Work Order ID 76245

Item Name: Crosstube, Low Narrow Aft. 412CF

DRAWING NO. D412-664-245	TITLE CROSSTUBE ASS'Y (412 LOW-N AFT)	REV. D	DART AEROSPACE LTD ENGINEERING ORDER		D.E.O. NO. D412-664-245-D-1	SHEET NO. SHEET 1 OF 2	SCALE NTS
DRAWN 97	CHECKED SC	MFG. APPR. B	APPROVED MP		DE APPR. H		
DATE 11.05.25	DATE 11.05.31	DATE 16.05.31	DATE 11/05/31		DATE 11.05.31

DRAWING NO. D412-664-245	TITLE CROSSTUBE ASS'Y (412 LOW-N AFT)	REV. D	DART AEROSPACE LTD ENGINEERING ORDER		D.E.O. NO. D412-664-245-D-2	SHEET NO. SHEET 1 OF 1	SCALE NTS
DRAWN JP	CHECKED ASS	MFG. APPR. EE	APPROVED MP		DE APPR. MP		
DATE 11.09.07	DATE 11.09.12	DATE 11.09.19	DATE 11.09.19		DATE 11.09.19

SECTION A-A D6-2
SCALE 4X

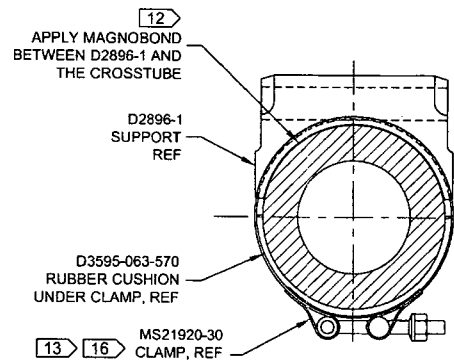
chafing shield RevC see DEO attached for placement
per ECN 12643

SECTION A-A
CHAFING SHIELD DETAIL
VIEW ROTATED, NOT TO SCALE

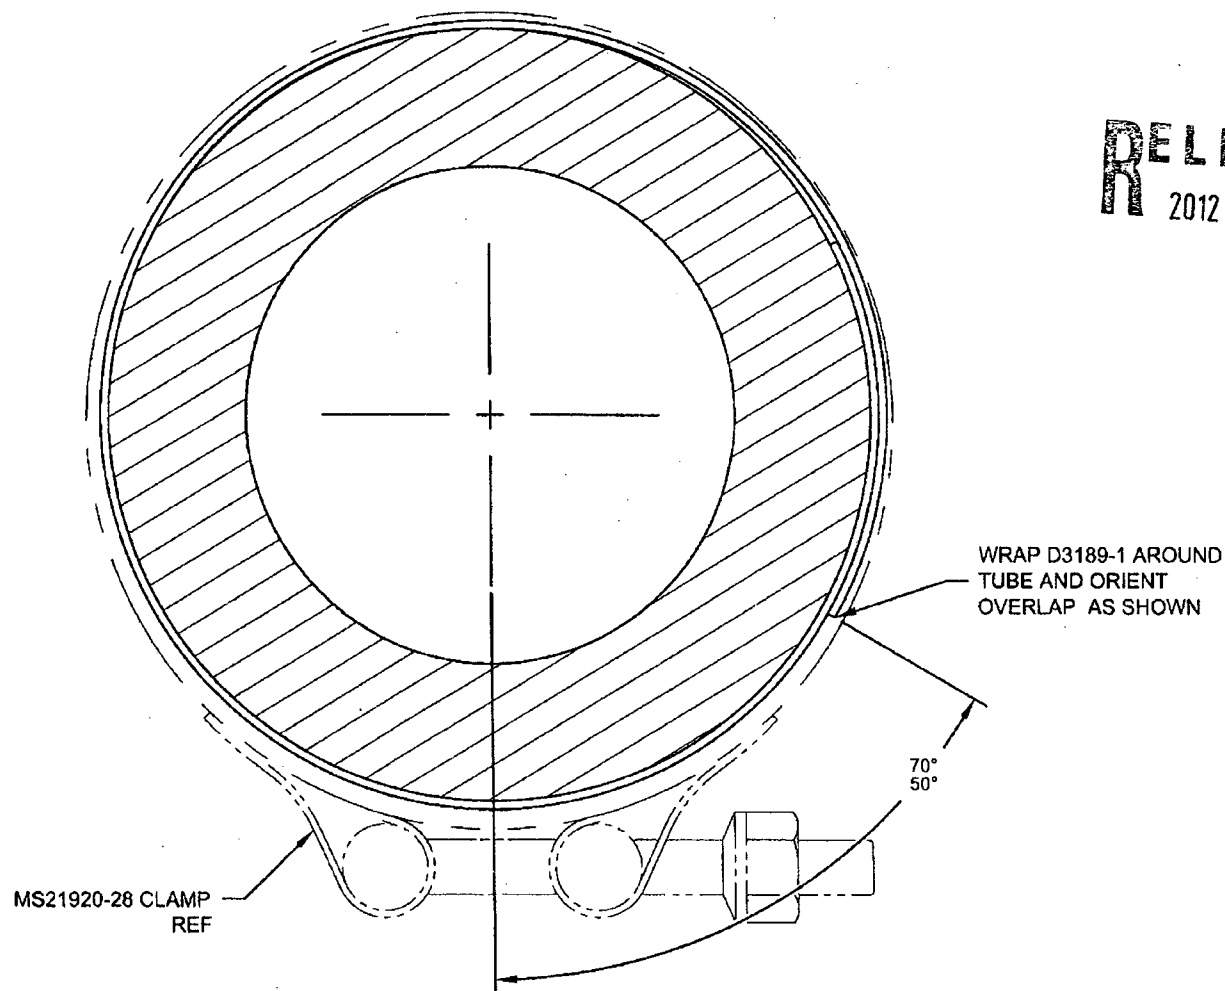
DRAWING NO. D412-664-245	TITLE CROSSTUBE ASS'Y (412 LOW-N AFT)	REV. D	DART AEROSPACE LTD ENGINEERING ORDER		D.E.O. NO. D412-664-245-D-3	SHEET NO. SHEET 1 OF 3	SCALE NTS
DRAWN <i>97</i>	CHECKED <i>J</i>	MFG. APPR. <i>JD</i>	APPROVED <i>140</i>		DE APPR. <i>[Signature]</i>		
DATE 12.08.21	DATE 12.08.30	DATE 12.08.30	DATE 12.08.30		DATE 12.08.30

NOTE 14 AND 16 ON SHEET 1 IS AMENDED AS FOLLOWS:
